Vacherie Community and Sports Complex
St. James Parish Government

ADDENDUM #3

Vacherie Community & Sports Complex for St. James Parish
22080 Champion St., Vacherie, LA

10 18" BRICK VENEER CMU SEAT WALL

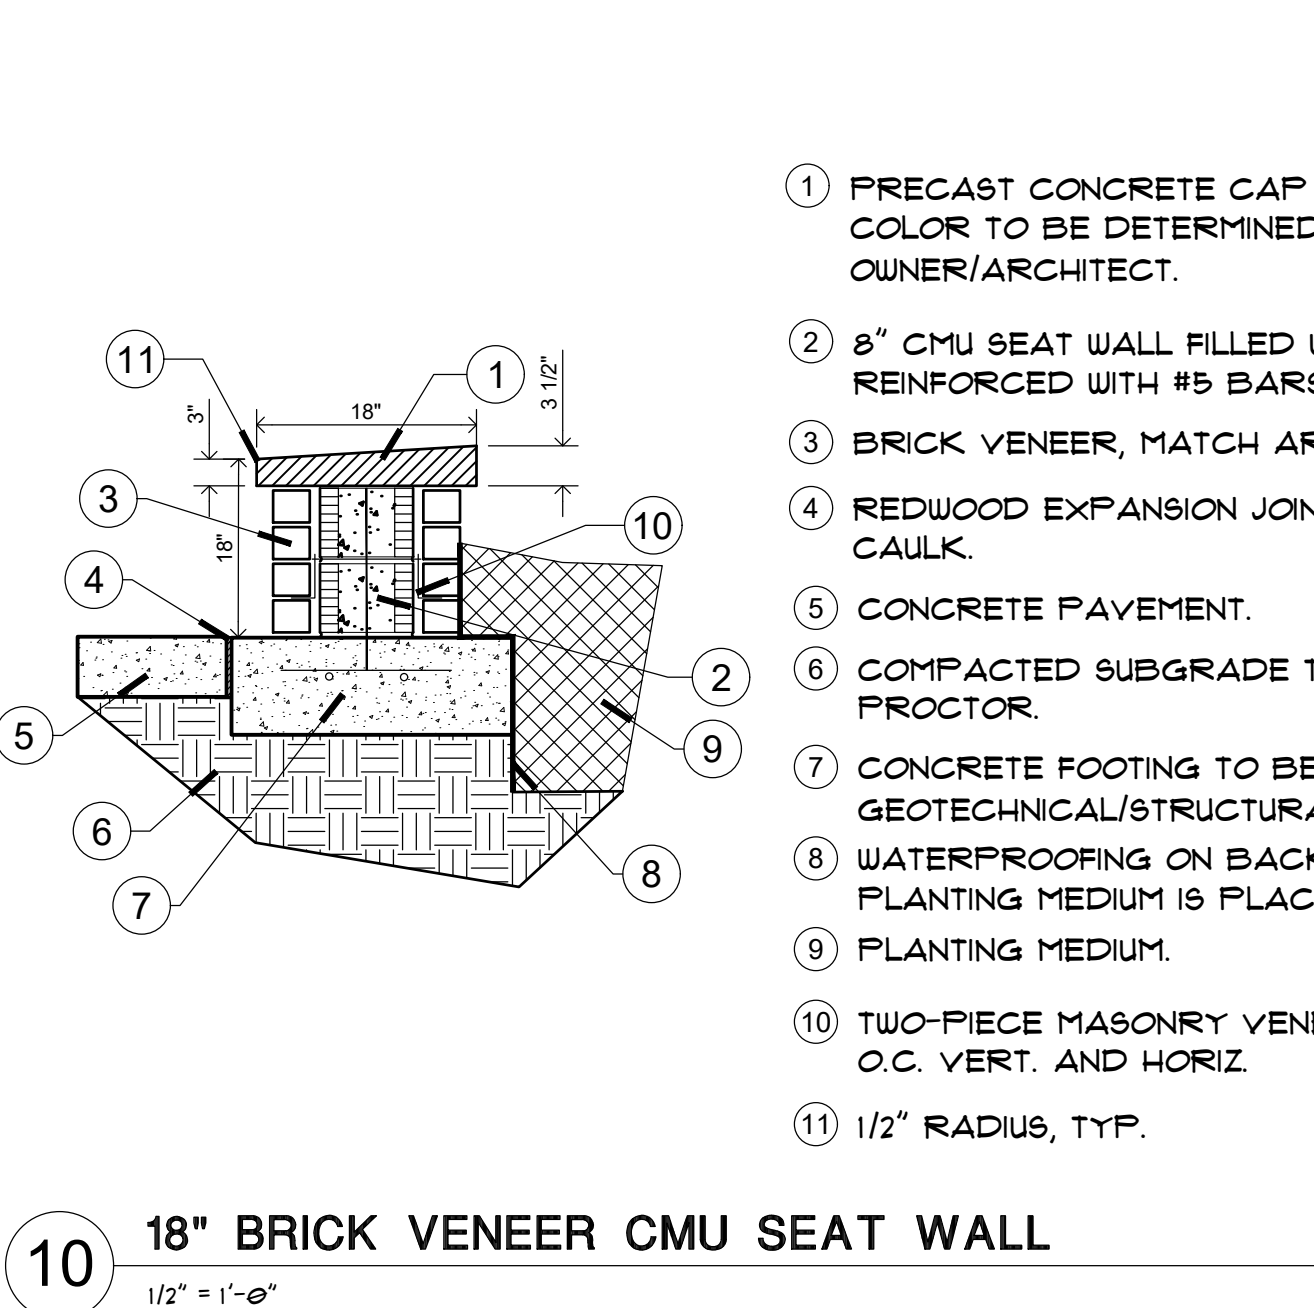
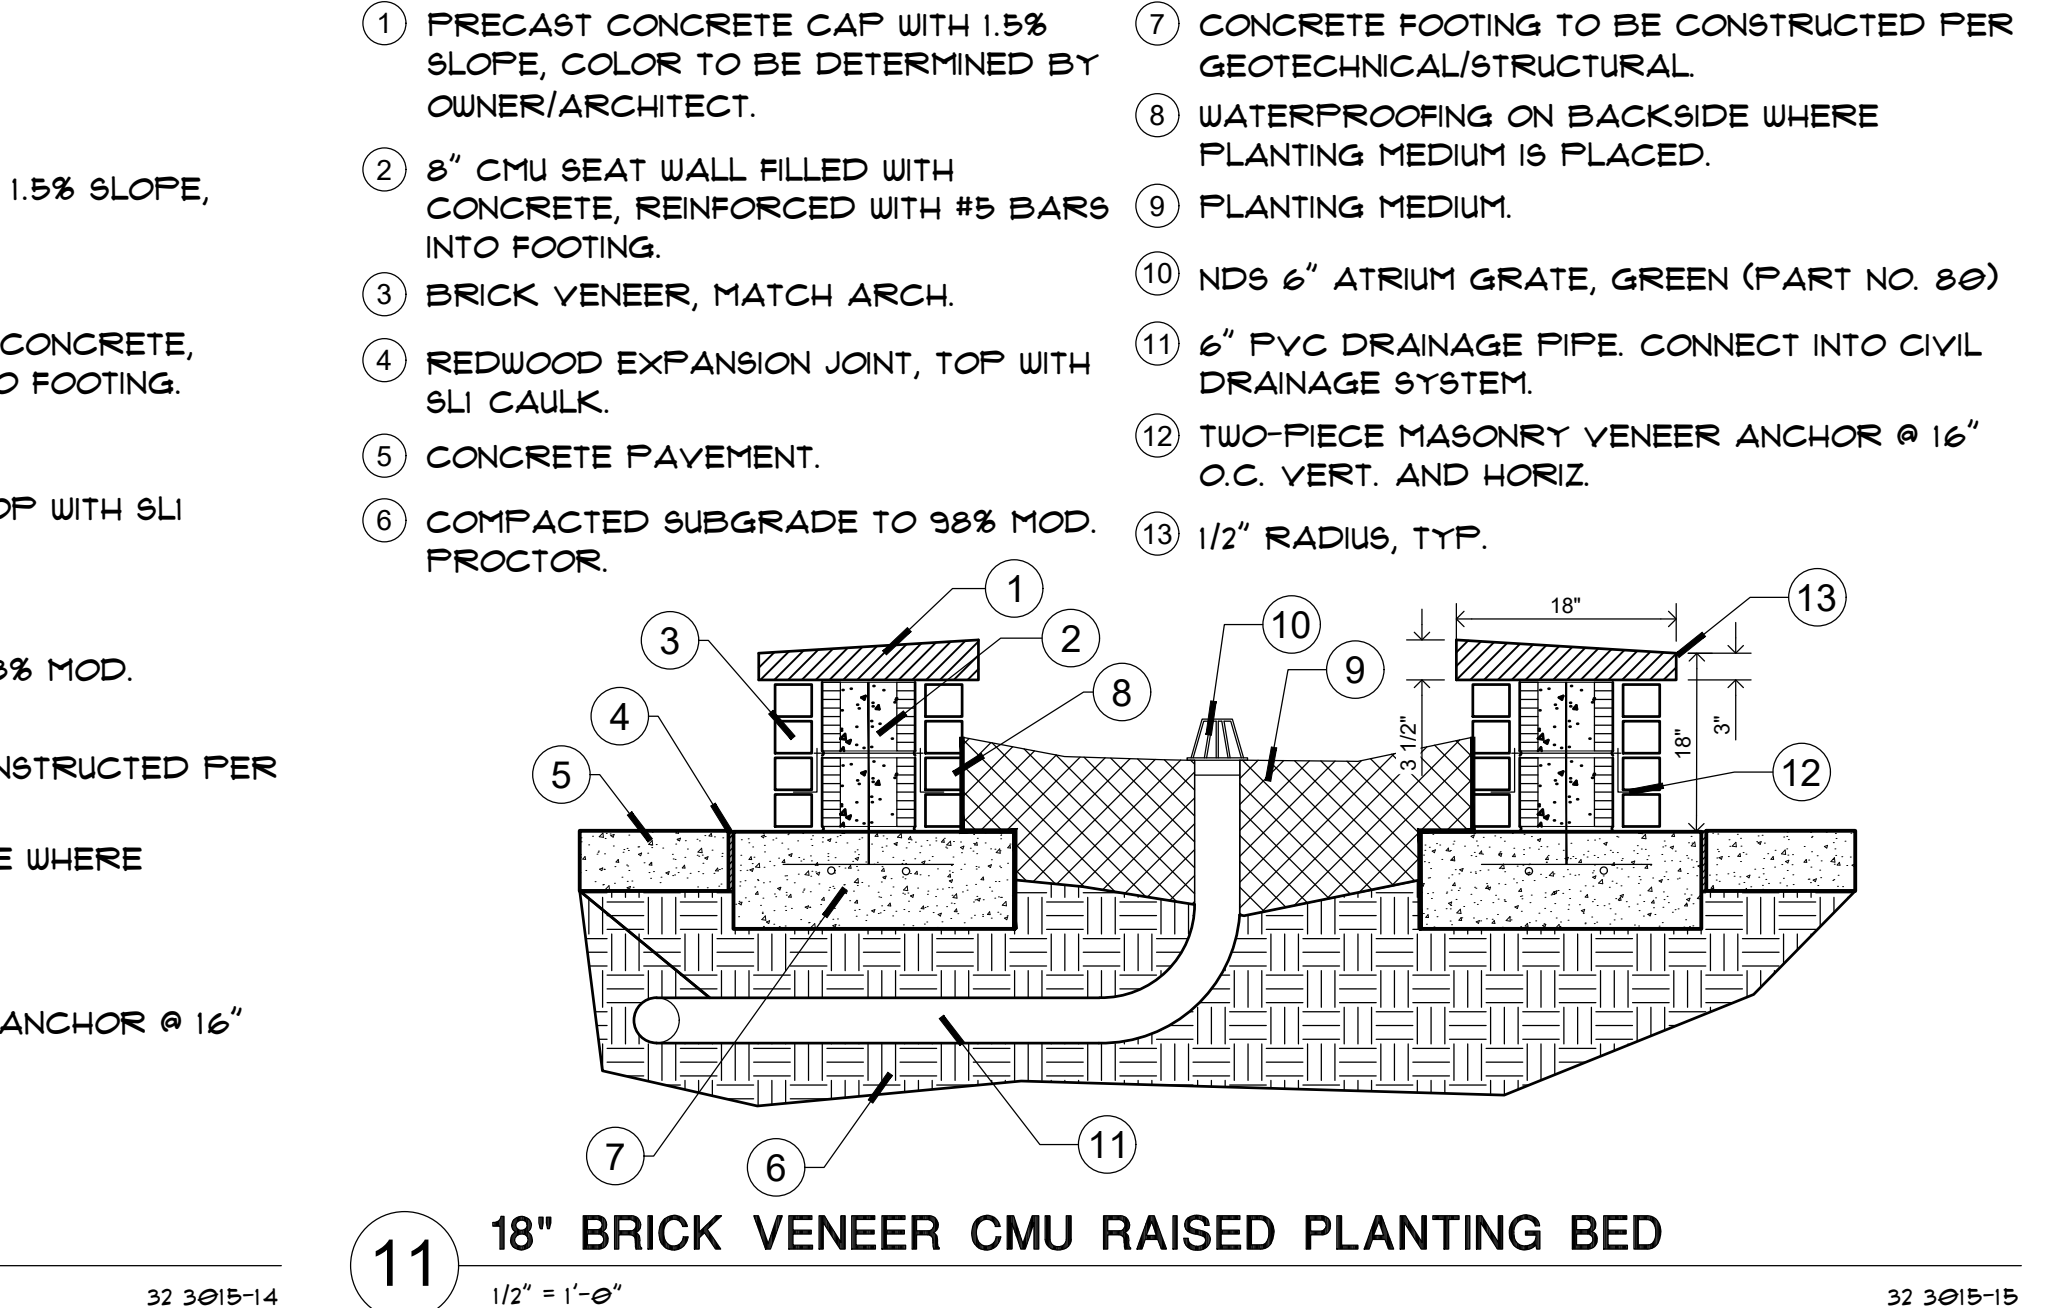
1. Drawings D-1, C-1.1, C-1.2, C-2, C-3, & C-4: The referenced drawings have been revised and are being reissued with this Addenda.
2. Drawings L-1.0 & L-1.1: The referenced Landscape drawings have been revised to include additional information and details on the masonry planter beds and bench.
